NATIONAL CAPITAL COMMISSION
COMMISSION DE LA CAPITALE NATIONALE

No.	2020-P154
	To	Board of Directors

PSPC Energy Services Acquisition Program (ESAP) – Federal Land Use and Design Approval (FLUDA) for Preliminary Developed Design of Level 3 project components and timeline-critical enabling work

Appendix C – Select Renderings and Drawings

Cliff Plant / Centrale Cliff

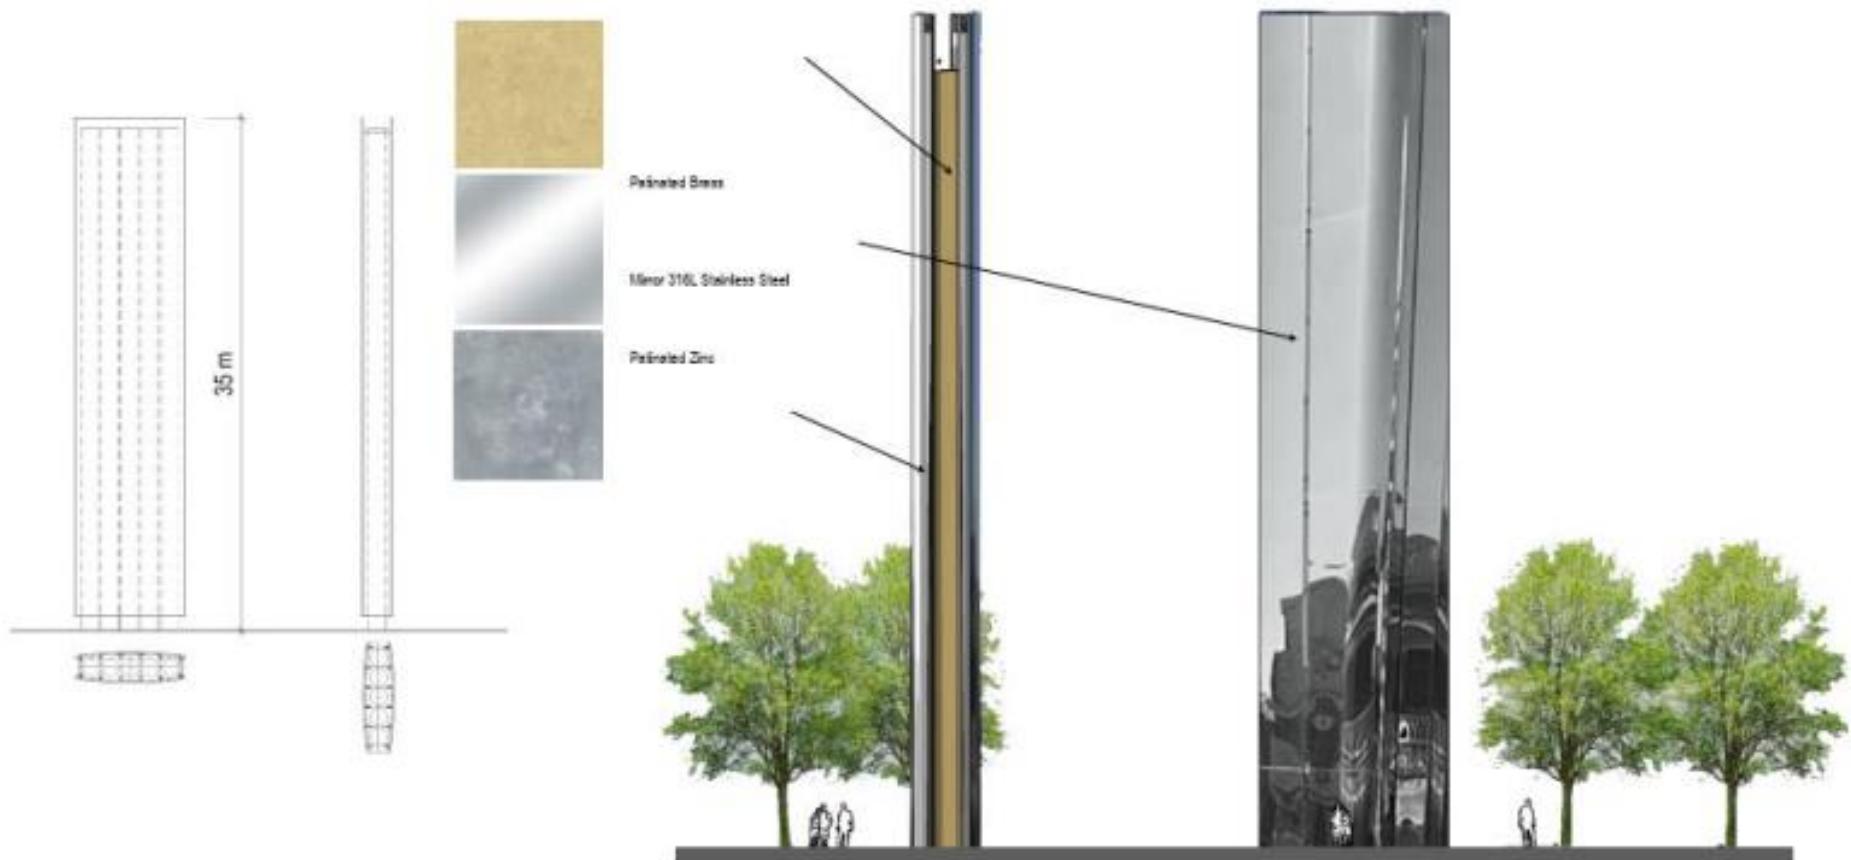
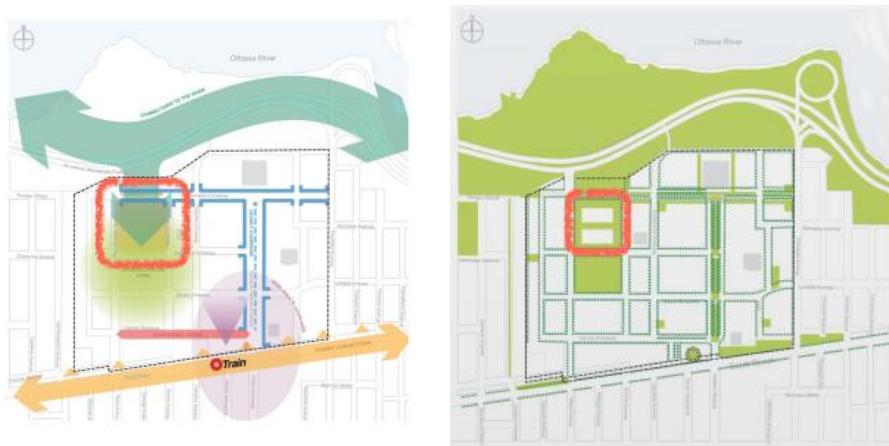
- More articulation is needed for the screen to appear as an extension of the natural escarpment.

- The building is too prominent on the cliff: it should be more subtle, better integrated.
- The roof is not related to other built elements in the vicinity.
- The arrival experience should be integrated better between the building and the pool. The entrance plaza may offer insufficient gathering space.
- Visitors should be able to walk over the pool in the absence of water during the winter months.
- The space feels tight and the edges hard: it needs to be more flexible, more sinuous, in the spirit of the circular skylights on the other side.
- Vertical circulation between the city and the walkway along the water is important.

- The architectural treatment is strong and positive.
- The stacks are well received. Matte stainless steel would be preferable both from a design perspective and ease of maintenance.

- The design lends itself well to the creation of a node for walks along the river.
- More detail is needed on the visitor centre design.

- A treatment to reduce the risk of reflected solar glare from the chimneys' mirrored steel material should be considered.
- The landscape approach at base of the plant should incorporate native planting to screen the service area.

- More detail is needed regarding the plant's architectural screen (drapery) to ensure the design resolution results in long-term viability and durability.

- Given the visual prominence of the screen, plant material could be integrated (e.g., climbing vines at the base of the plant) to improve views. The screen should be porous to achieve the desired visual effect.

- Members requested additional views including a night view and additional perspectives from the base of the plant, the Portage Bridge, and Gatineau.
- More information should be provided regarding how the theatre boxes and other components of the design will be lit. Lighting will need to be sensitive to the context.

Tunney's Pasture Plant / Centrale du pré Tunney

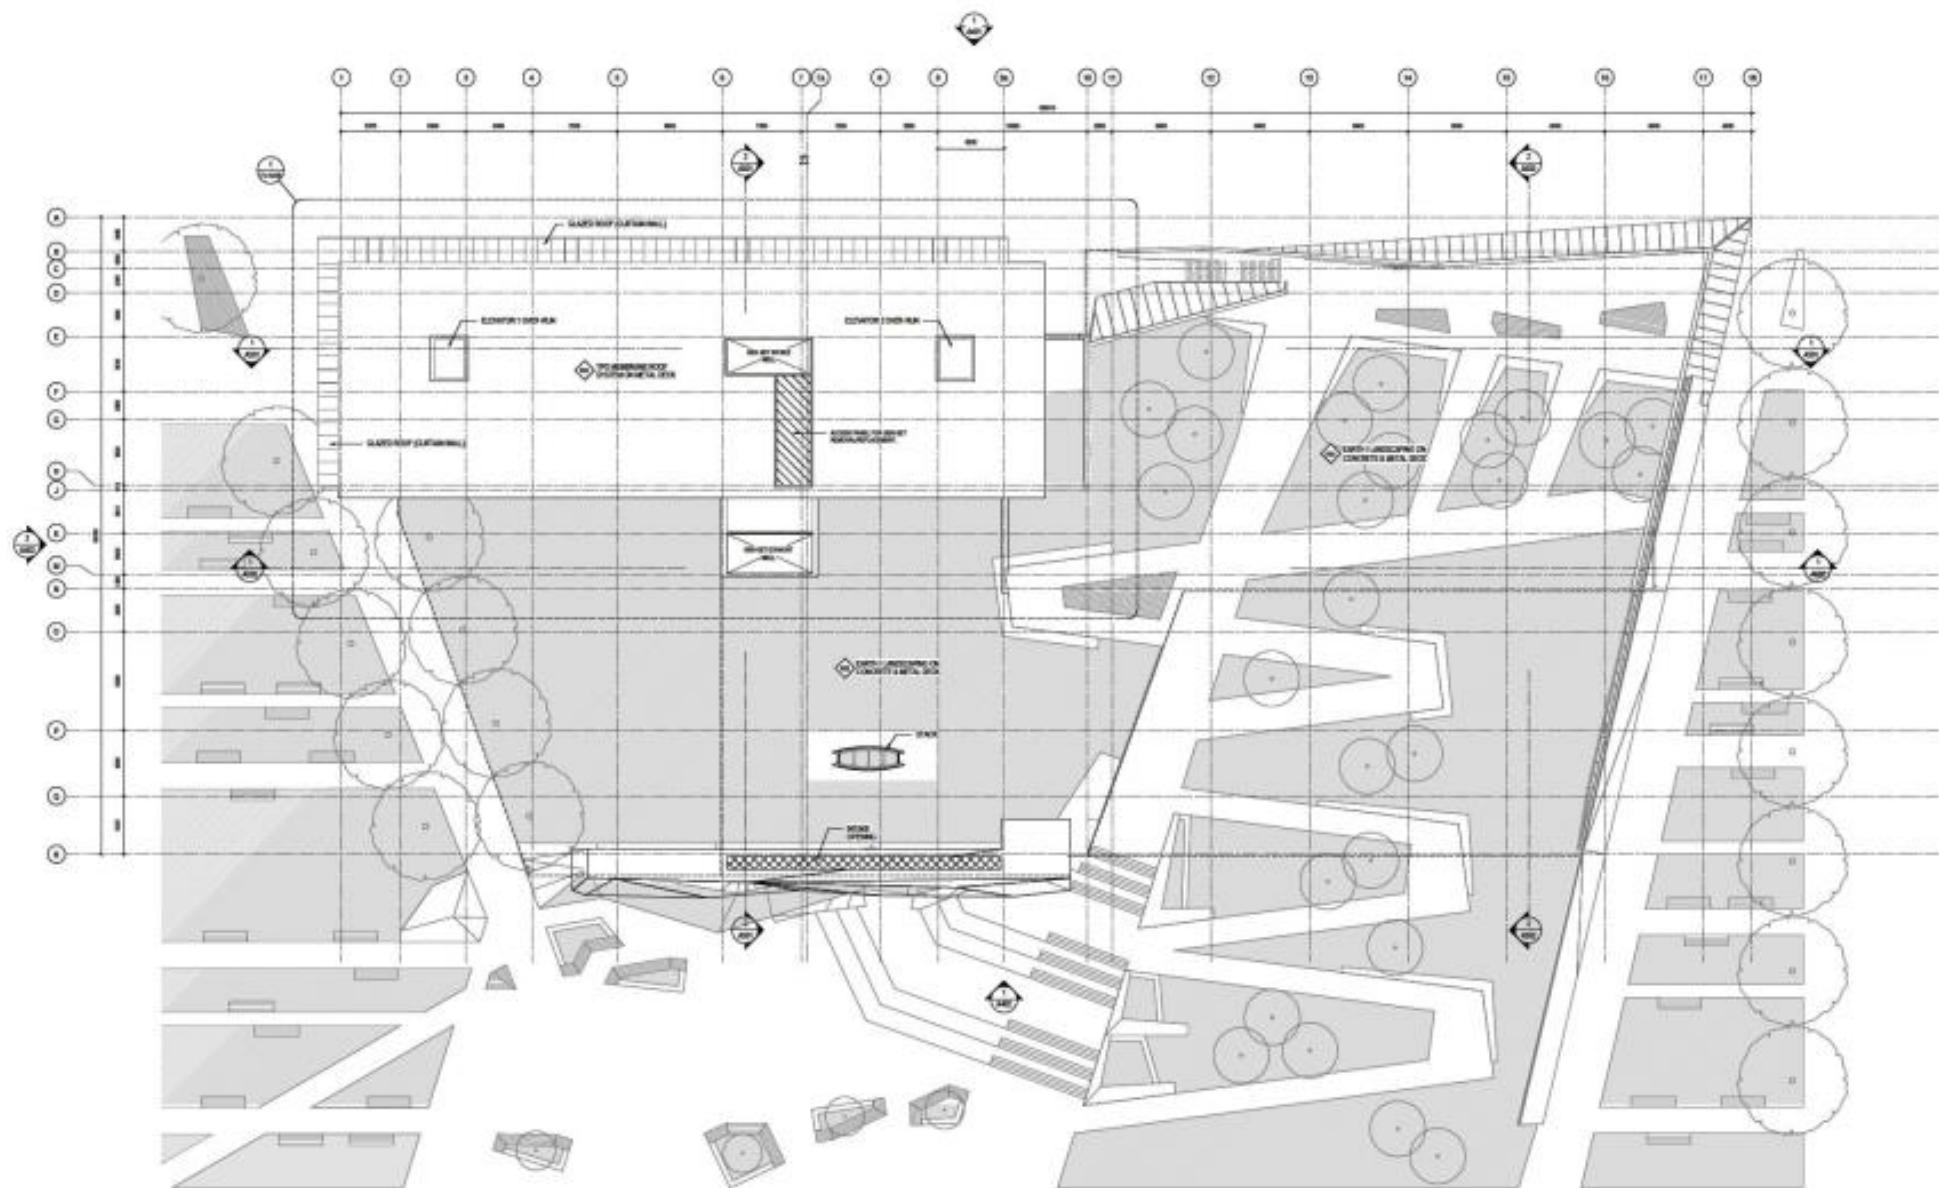
- The building does not look like it belongs there. The facility should be refined to fit within the landscape and the planned redevelopment. It should help facilitate connectivity from Tunney's Pasture to the riverfront greenspace.
- The loading dock location next to a planned community facility may be a concern.
- The green roof should be designed carefully for it to be effective.

- Members discussed the landscape approach for the green roof: formalized horticulture or a more naturalized approach.
- Further information is required regarding maintenance and public access during the winter months.

- Planting and landscaped area should be maximized for this site.
- Trees should be integrated carefully, as tree pits or grates are not the best option.

River Pump Station at Jacques Cartier Park / Station de pompage de l'eau de la rivière au parc Jacques Cartier

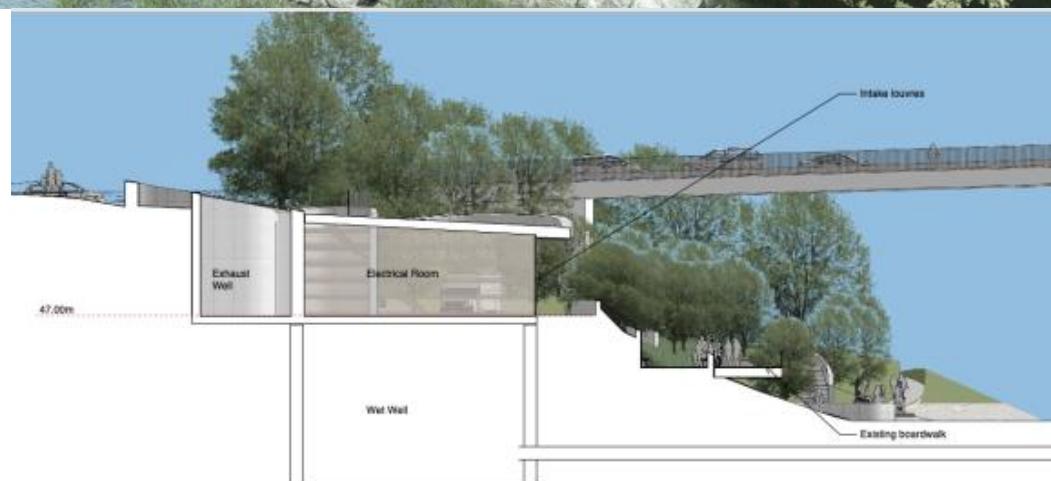
- The pumping station should be pushed further back from the shoreline and include a vegetated screen.

- The pump station is well resolved and fits well in the context. The combination of concrete and wood is elegant.
- Members appreciated the prevalence of landscape over architecture, and the landscaped roof that takes advantage of the topography.
- Access to the green roof should be considered. Access to restricted areas should be resolved with the use of landscape instead of fences.

- Weathering steel may be better suited than wood for durability and resistance to vandalism. Surfaces should be designed to facilitate cleaning if vandalism occurs.
- The addition of vegetation that would cover the building over time would prevent vandalism due to exposed surfaces.
- Screening the service dock with a sliding door should be considered.

- More analysis is required on access to water and flooding.
- Balance should be found between access to water and risks associated with flooding: seasonal use with removable docks should be considered.
- The river banks should be left to regenerate naturally.
